INTERMOUNTAIN POWER SERVICE CORPORATION

FACSIMILE COVER SHEET

COMMENTS: Copy of my notes on Babcock Draining.

STRUCTURAL STEEL ARRANGEMENT
PLAN AT EL. 4816'-6"

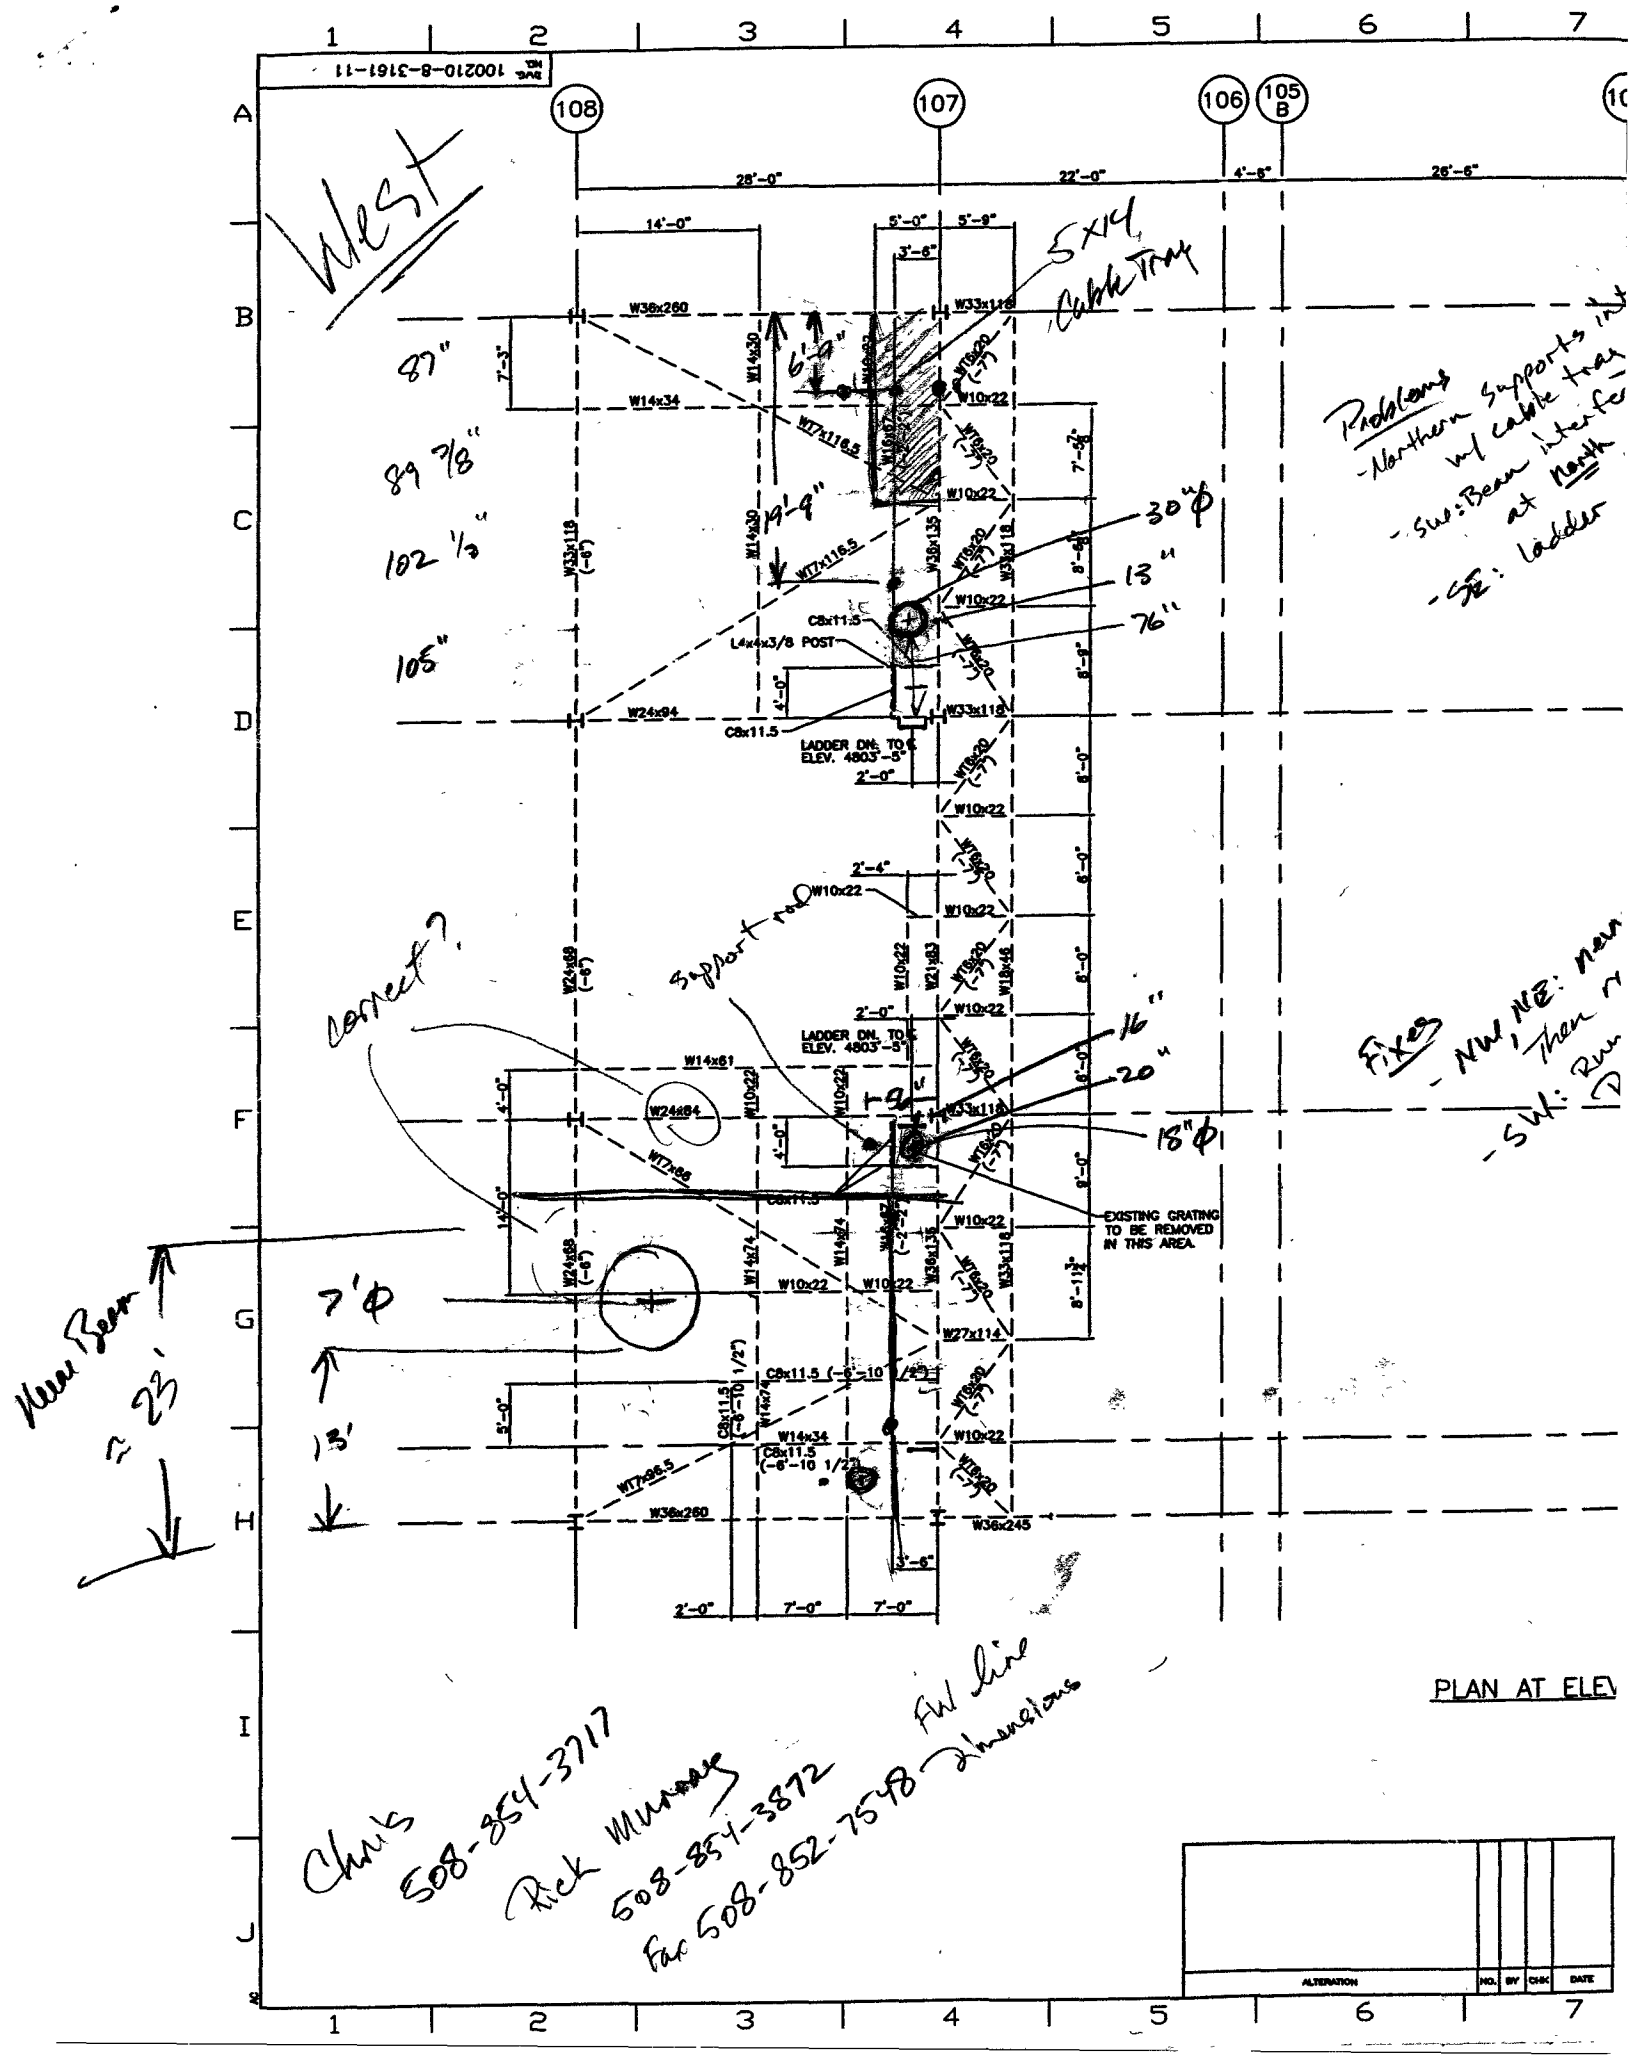
West
5x14 Cable Tray
87"
89 7/8"
102 1/2"
105"
6'-9"
19'-9"
30"φ
13"
76"
16"
20"
18"φ
7'φ
13'
Near Beam ≈ 23'
correct?
support rod
Problems
- Northern supports int w/ cable tray
- SW: Beam interfe at north
- SE: ladder
Fixes
- NW, NE: mem Then r
- SW: Run
EXISTING GRATING TO BE REMOVED IN THIS AREA.
LADDER DN. TO ELEV. 4803'-5"
L4x4x3/8 POST
PLAN AT ELEV
Chris 508-854-3717
Rick Murray 508-854-3872
Fax 508-852-7548
FW line dimensions
ALTERATION
NO.
BY
CHK
DATE

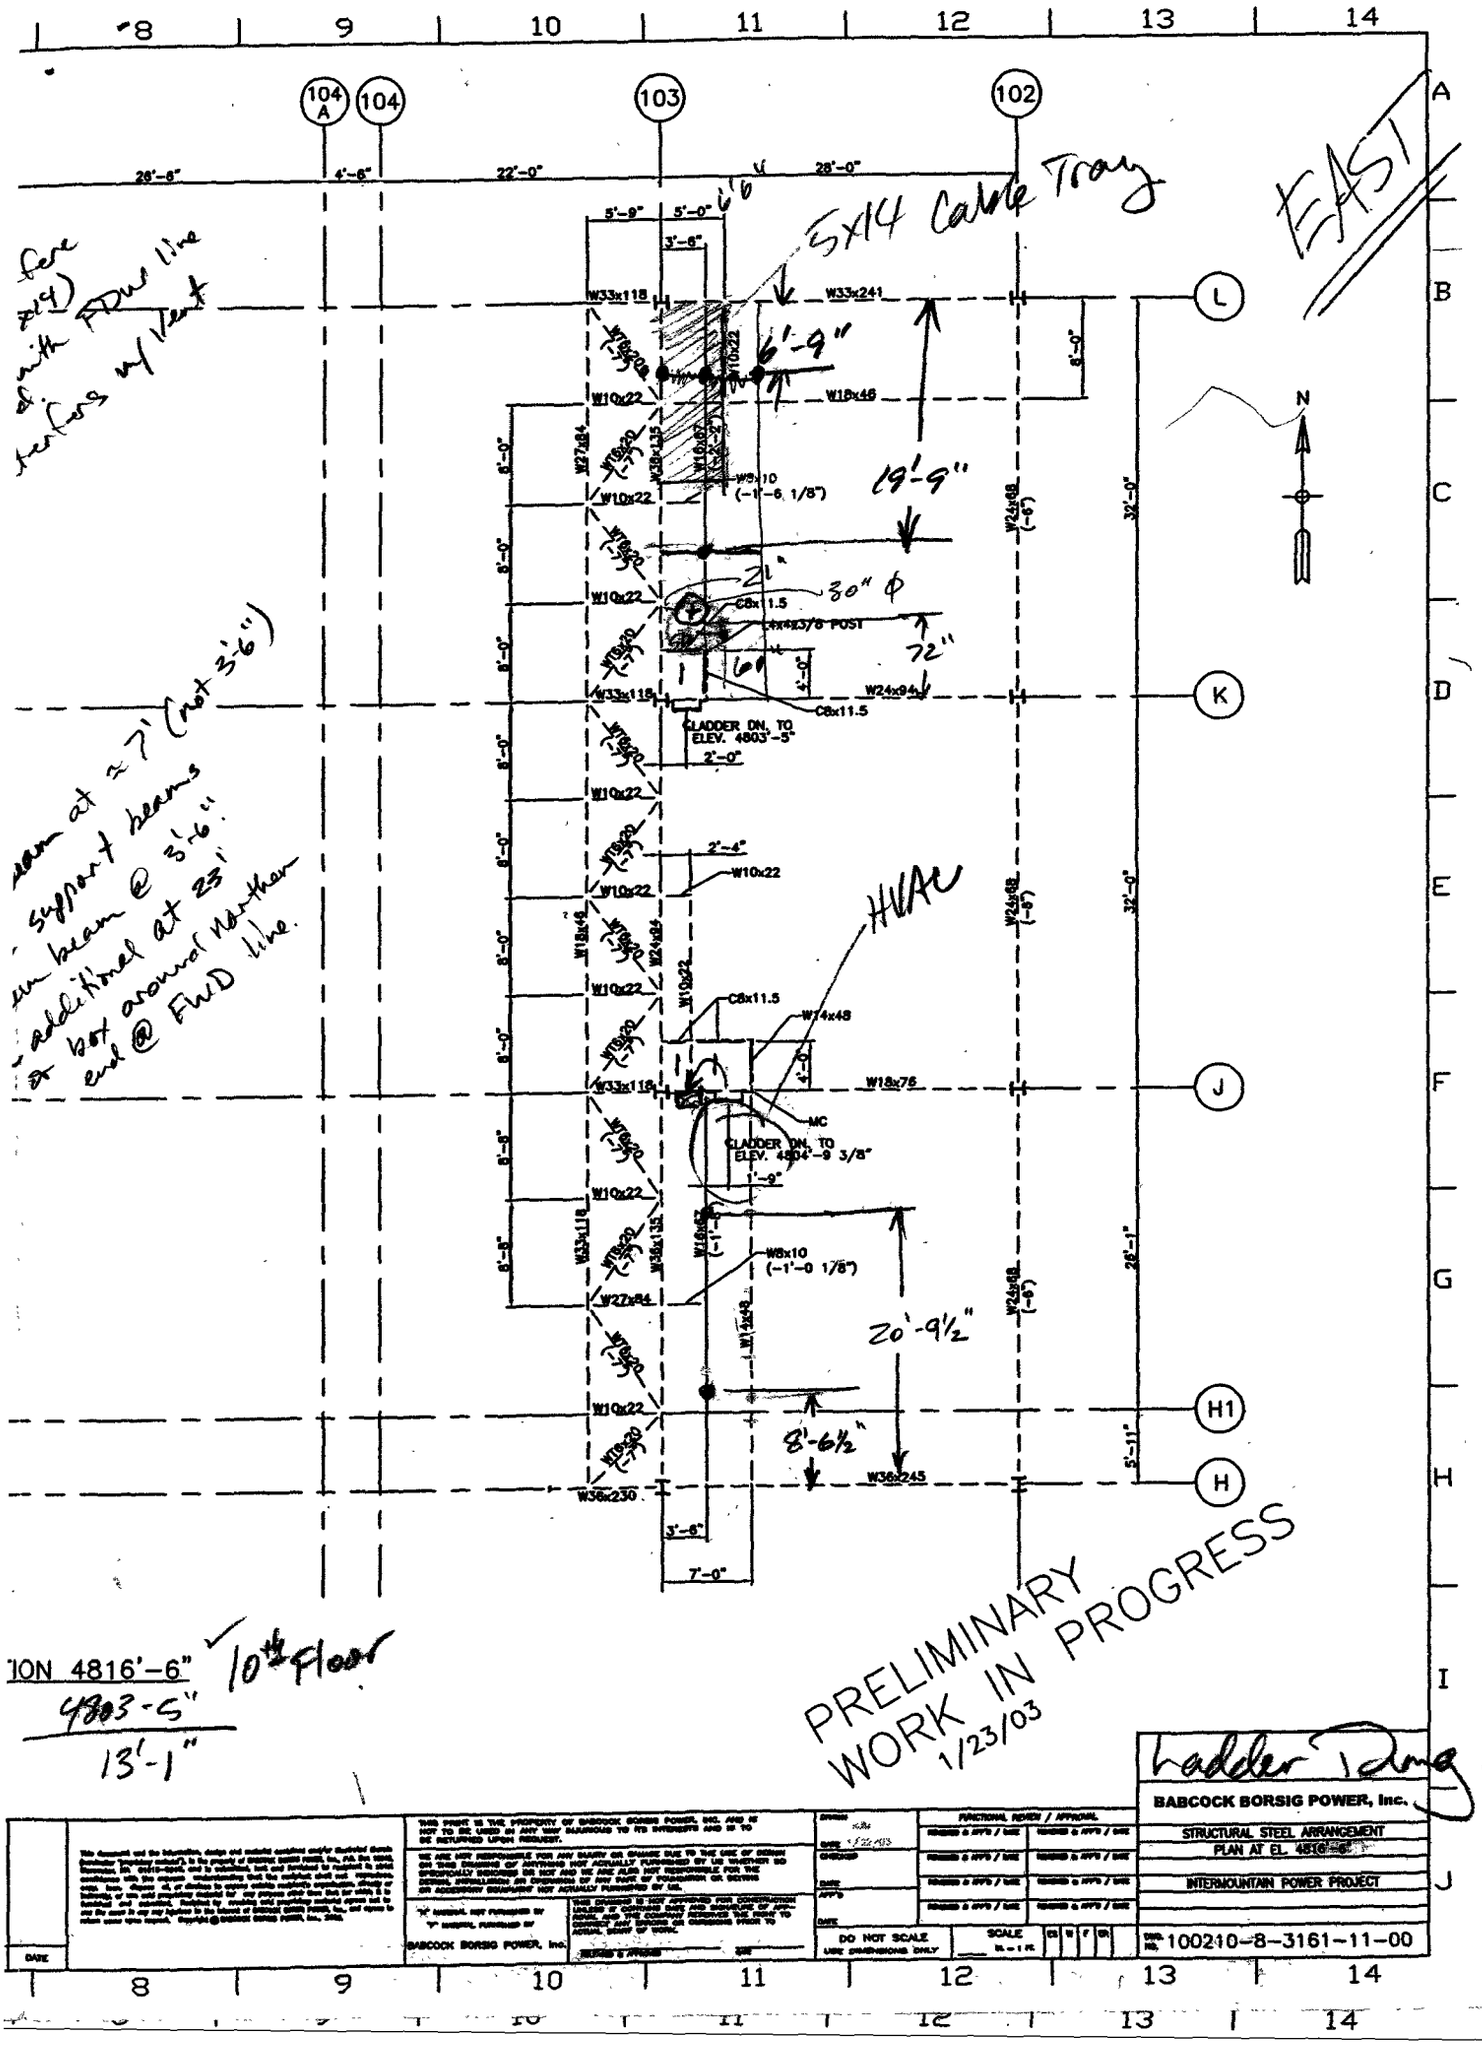
PRELIMINARY WORK IN PROGRESS
1/23/03

Ladder Dwg.
